**DOCUMENT 00 90 00  
ADDENDUM**

**ADDENDUM NO. [2]                      Date: November 8, 2018**

**RE:                      GLENWOOD COMMUNITY SCHOOL DISTRICT  
ATHLETIC COMPLEX IMPROVEMENTS BID PACKAGE 2 REBID  
400 SIVERS ROAD  
GLENWOOD, IOWA 51534  
HSR PROJECT NO. 18005**

**A302R**

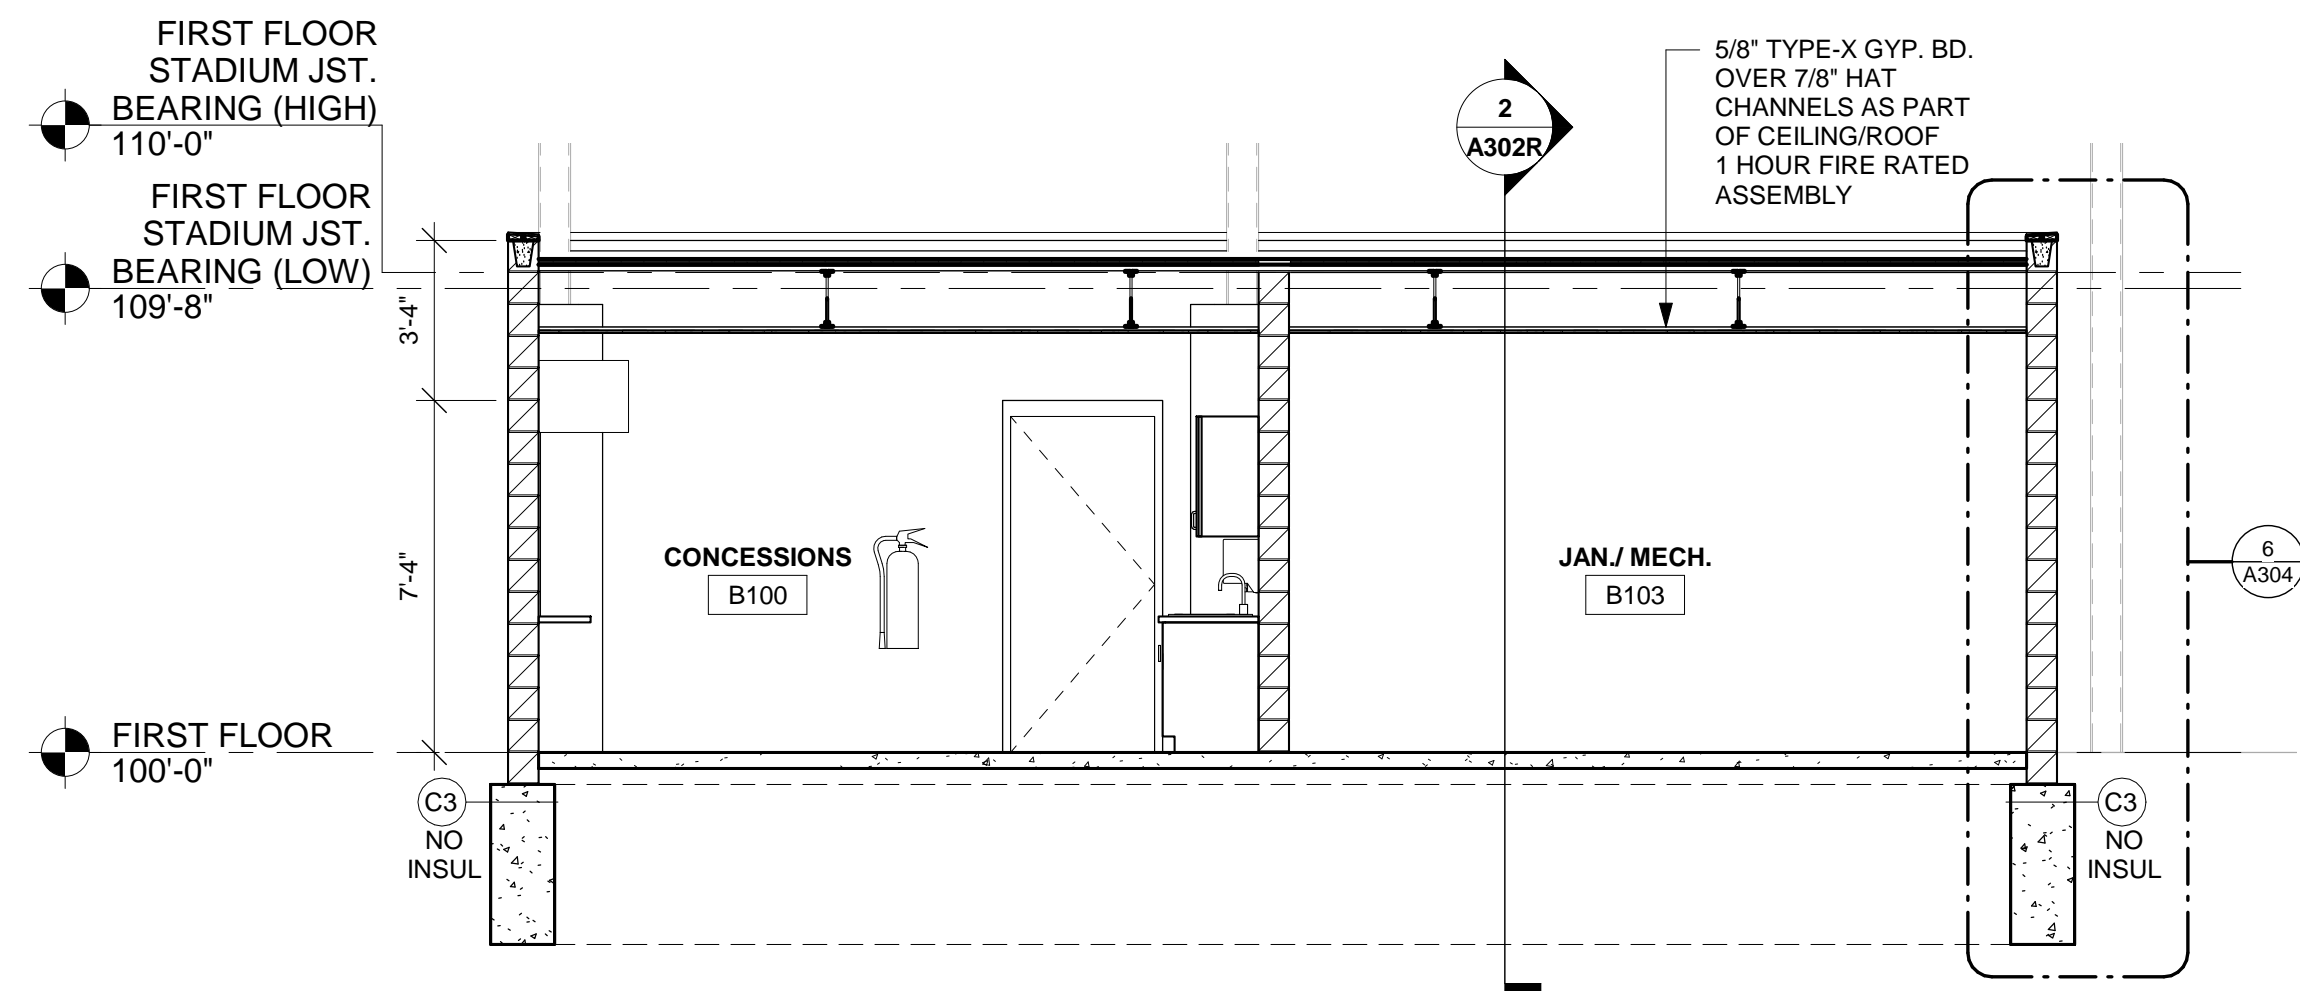
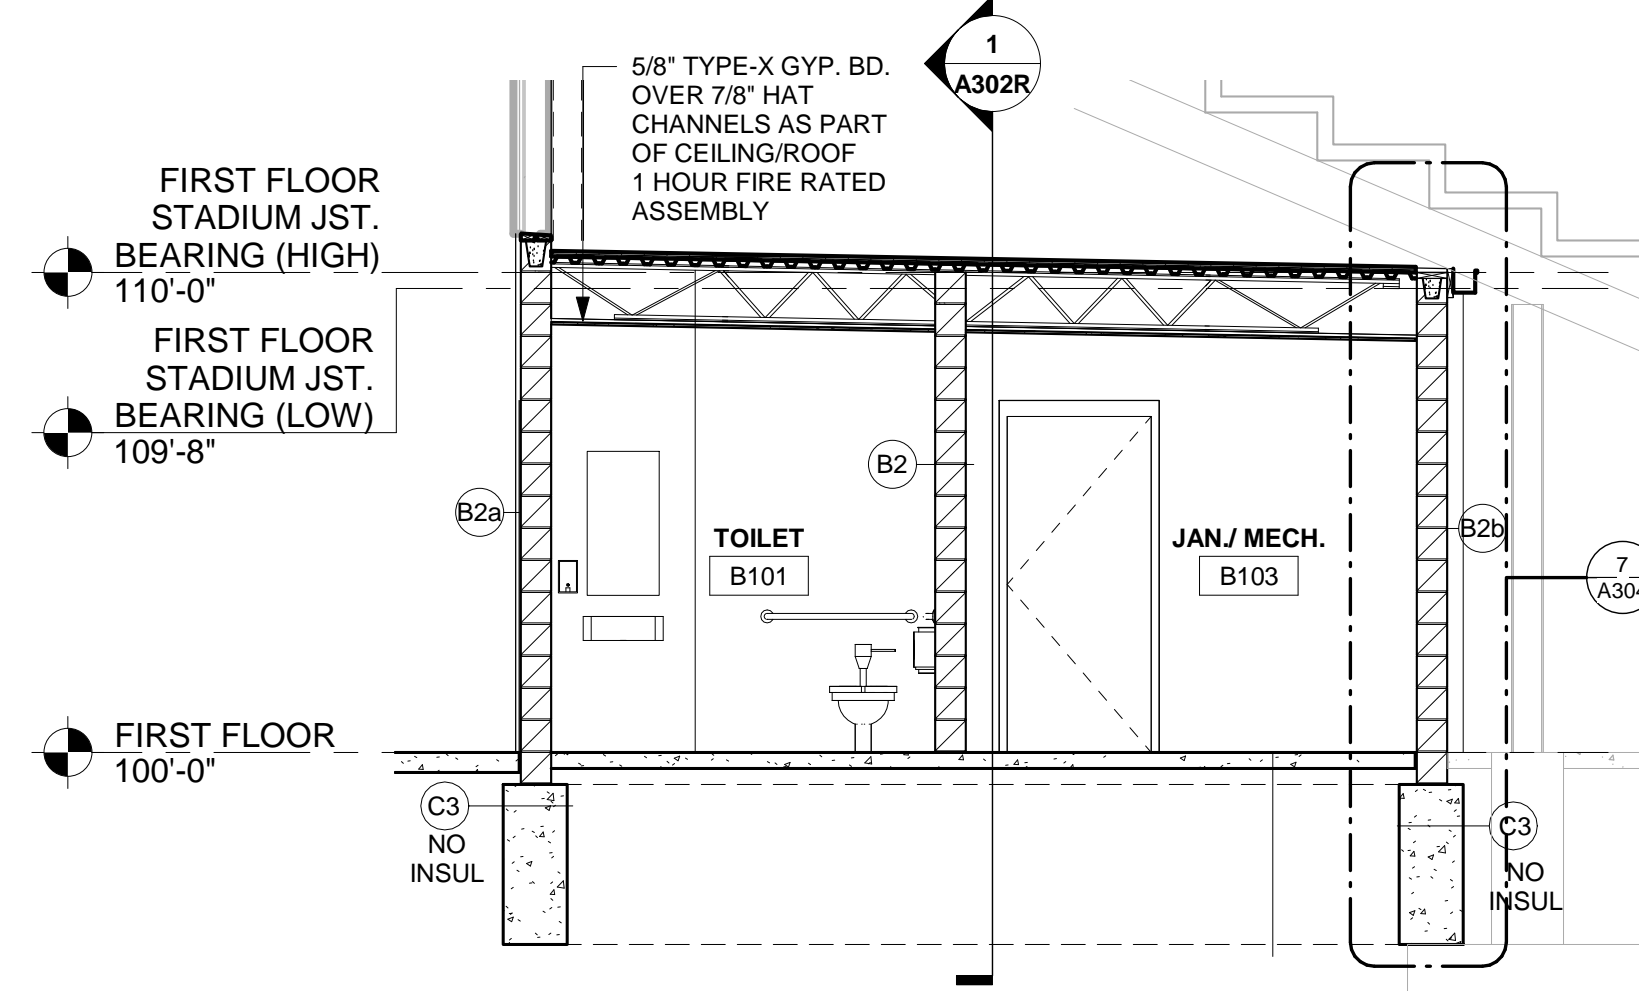
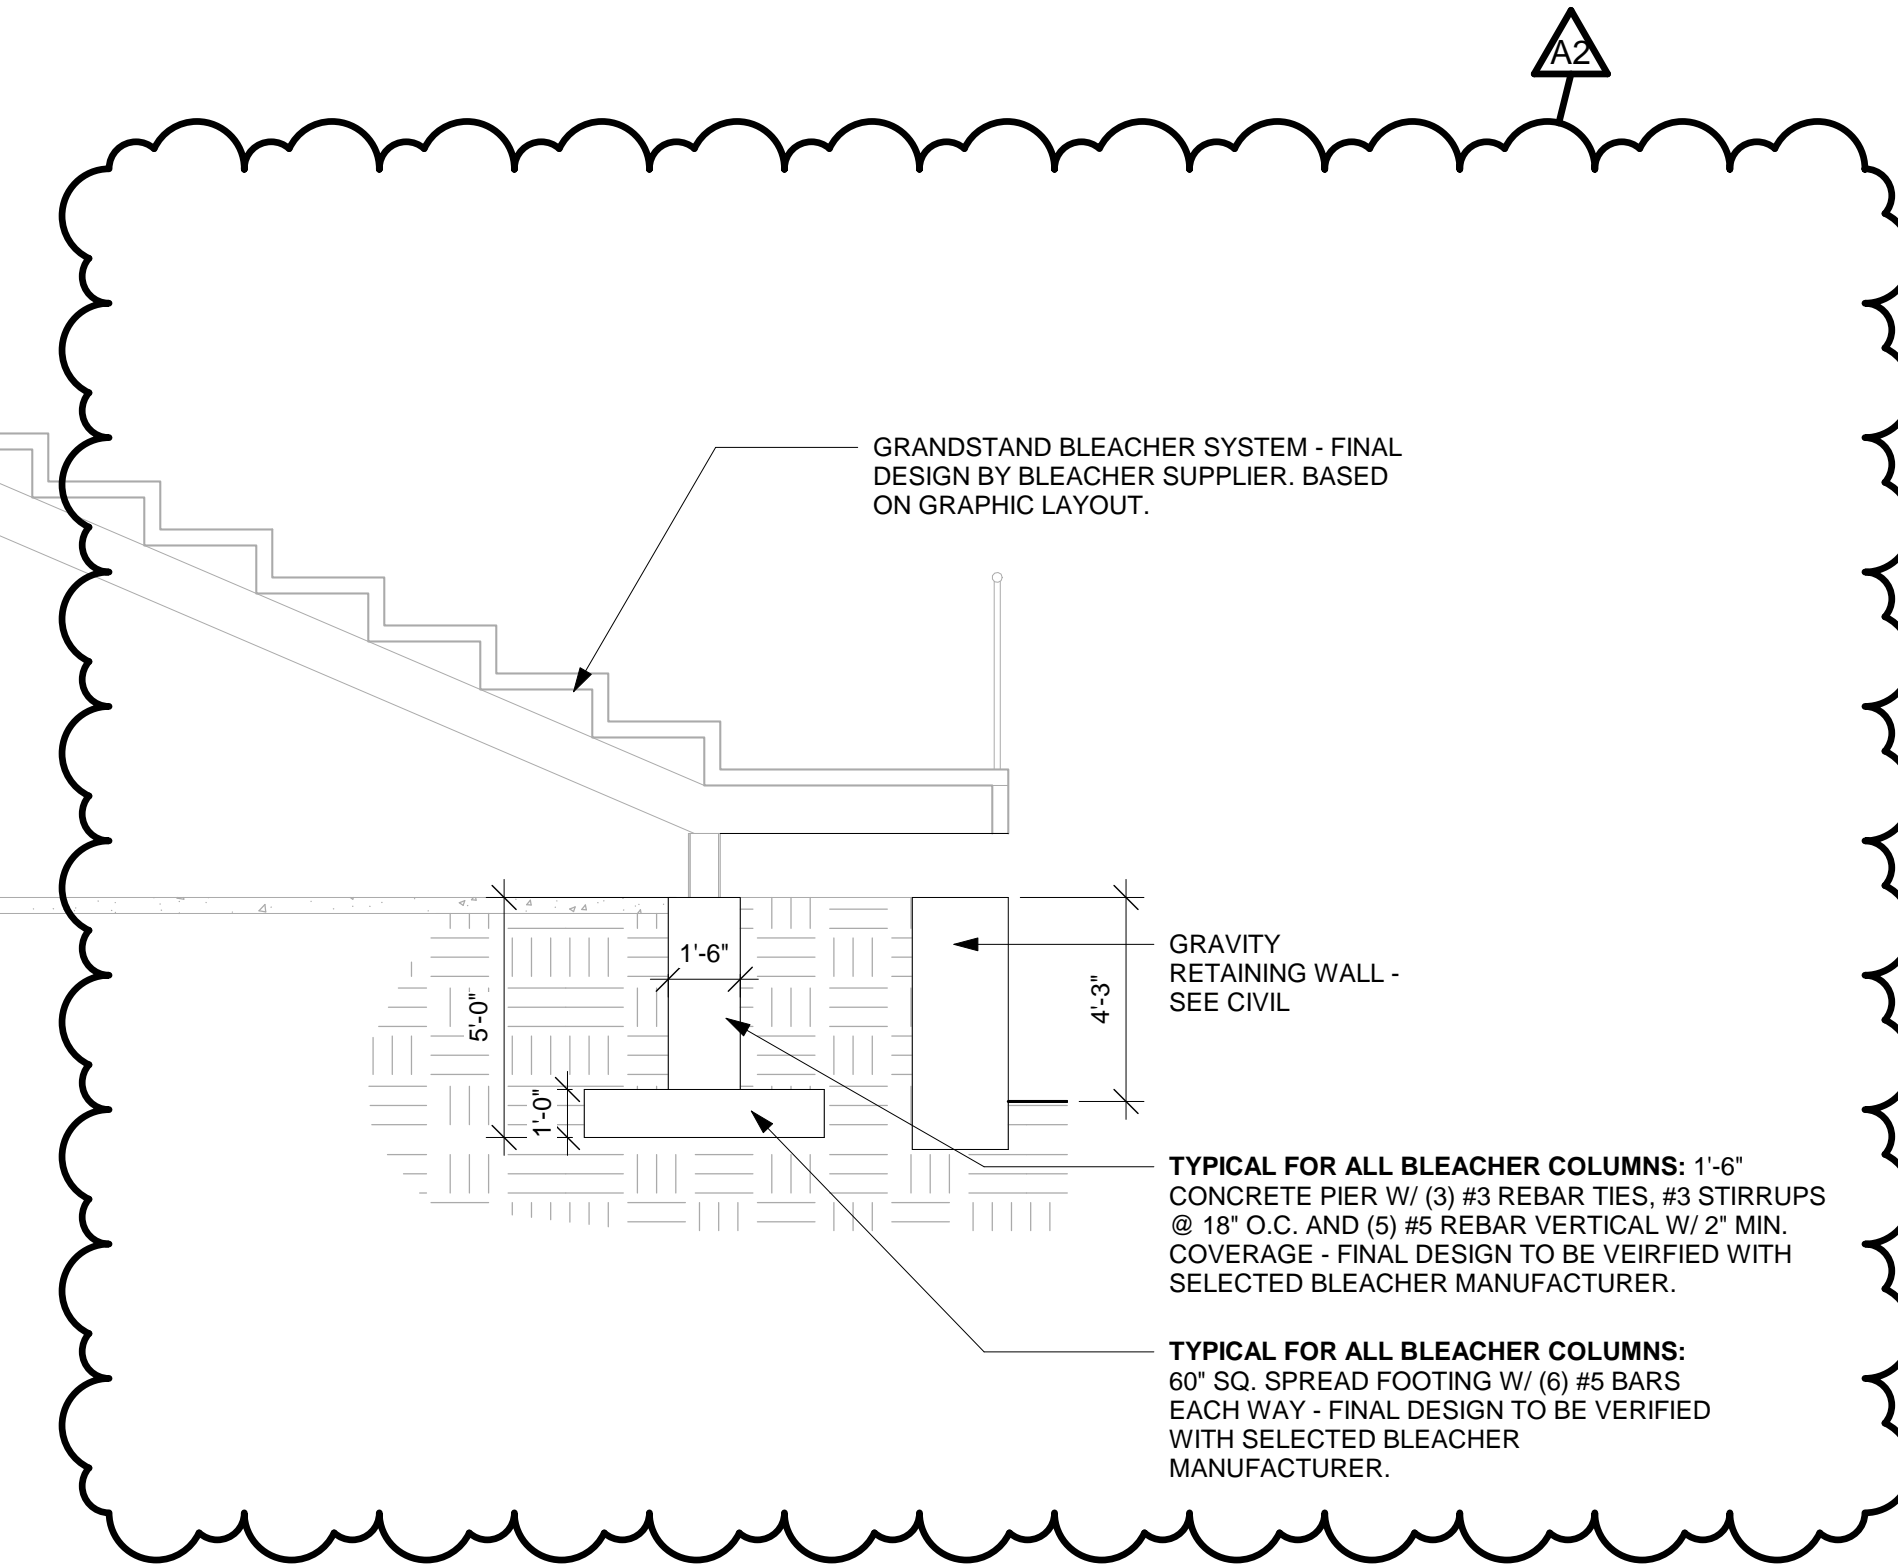
5. Sheet A101R FIRST FLOOR STADIUM PLAN 30 x 42 Drawing attached hereto
  - a. Revisions clouded on Drawing.
6. Sheet A302R FIRST FLOOR STADIUM BUILDING SECTIONS 30 x 42 Drawing attached hereto
  - a. Revisions clouded on Drawing.
7. Sheet P104R PLUMBING AND GAS RISERS 30 x 42 Drawing attached hereto
  - a. Revisions clouded on Drawing.
8. Sheet E101R FIRST FLOOR STADIUM LIGHTING PLAN 30 x 42 Drawing attached hereto
  - a. Revisions clouded on Drawing.
9. Sheet E102R SECOND FLOOR PRESS BOX LIGHTING PLAN 30 x 42 Drawing attached hereto
  - a. Revisions clouded on Drawing.
